Service Bulletin

Bulletin 2003-47-ABDE

SUBJECT: Electrode Positioning in Invensys Pilot Assemblies

This bulletin supercedes Bulletin 2001-45-ABDE, Electrode Gap in Electronic Pilot Assemblies.

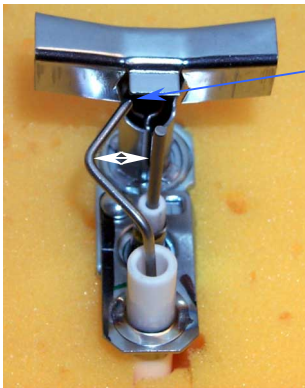
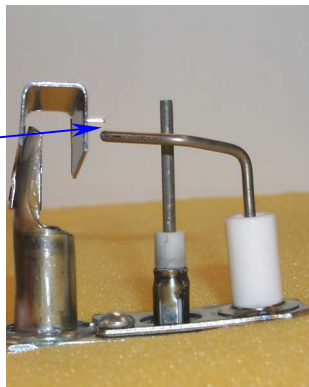
Incorrect electrode position on electronic pilot assemblies in Dean Decathlon (D50, D60, D80) fryers can cause intermittent problems in the ignition circuit. If the customer complains that the fryer takes too long in melt-cycle, or intermittently loses temperature during operation, the electrode position should be checked and properly adjusted.

The electrode tip is properly positioned just under the pilot hood deflector corner. (Note orientation of electrode in relation to deflector corner.)

Maintain maximum obtainable distance (white arrows) between electrode and flame sensor when positioning electrode tip with pilot hood.

Once in the proper position, adjust electrode gap to 1/8" between electrode tip and the pilot hood deflector.

DO NOT EXCEED 1/8" GAP ± 1/64". THE GAP AND ELECTRODE-TIP POSITION ARE CRUCIAL FOR PROPER OPERATION.

After the electrode is positioned and properly adjusted, ensure the flame completely engulfs the flame sensor at all times during operation. Check the pilot flame with all frypots heating to ensure there is no loss of pilot flame.

The electrode position in relation to the pilot hood deflector is crucial to accurate ignition. If the electrode is out of adjustment, the spark current will seek an alternate path to the flame-sense rod, causing ignition circuit failure.
